# Access Compliance Report

### (Curb Ramps)

Intersection ID: 10029993	Main Street: LANCASTER_HY	Cross Street: N/A	Location: SE
ADA ID: 7BE340F5DA24	Ramp Type: Perp	Initial Pass/Fail: Fail	Overall Compliance: No
Severity Score: 25			
Codes/Mitigation Info/Possible Solution		Field Measurements/Component Compliance

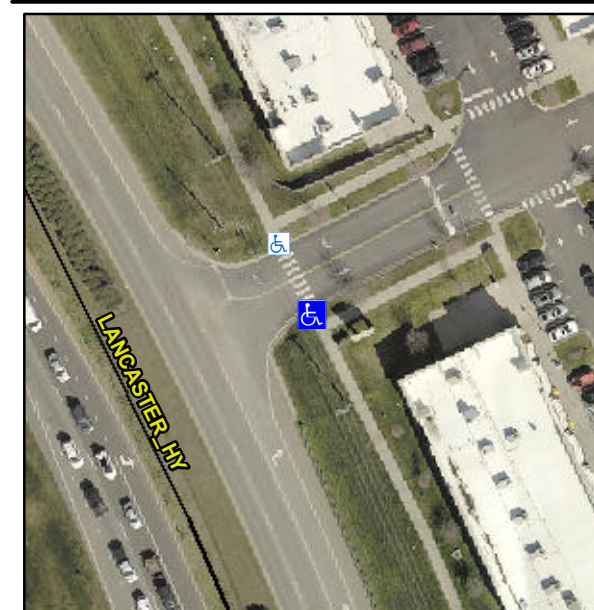
**Not Found, R304.2.2, R304.5.3**

Compliance	Description	Data	Compliance	Description	Data
N/A	Ramp Length (in)	95.0	No	Ramp Slope (%)	8.4
Yes	Ramp Width (in)	48.0	No	Ramp XSlope (%)	5.7
N/A	Flare Type LT	N/A	N/A	Flare Type RT	N/A
N/A	Flare Slope LT (%)	N/A	N/A	Flare Slope RT (%)	N/A
N/A	Flare Traversable LT?	N/A	N/A	Flare Traversable RT?	N/A
N/A	Landing Length (in)	N/A	N/A	DWS Provided?	N/A
N/A	Landing Width (in)	N/A	N/A	DWS Contrast?	N/A
N/A	Landing Slope (%)	N/A	N/A	DWS Length (in)	N/A
N/A	Landing X Slope (%)	N/A	N/A	DWS Full Width?	N/A
N/A	Landing Curb? (Y/N)	N/A	N/A	DWS Offset (in)	N/A
N/A	Shared Landing?	N/A			
N/A	Gutter Ponding?	N/A	N/A	Gutter Slope (%)	N/A
N/A	Gutter Lip Ht (in)	N/A	N/A	Gutter X Slope (%)	N/A
N/A	Painted X Walk1?	Yes	N/A	Painted X Walk2?	N/A
	X Walk 1 Direction	To N		X Walk 2 Direction	N/A
N/A	X Walk 1 Width (in)	96.0	N/A	X Walk 2 Width (in)	N/A
	X Walk 1 Slope (%)	0.2		X Walk 2 Slope (%)	N/A
	X Walk 1 X Slope (%)	11.0		X Walk 2 X Slope (%)	N/A

**Remove & Replace Entire Ramp.**
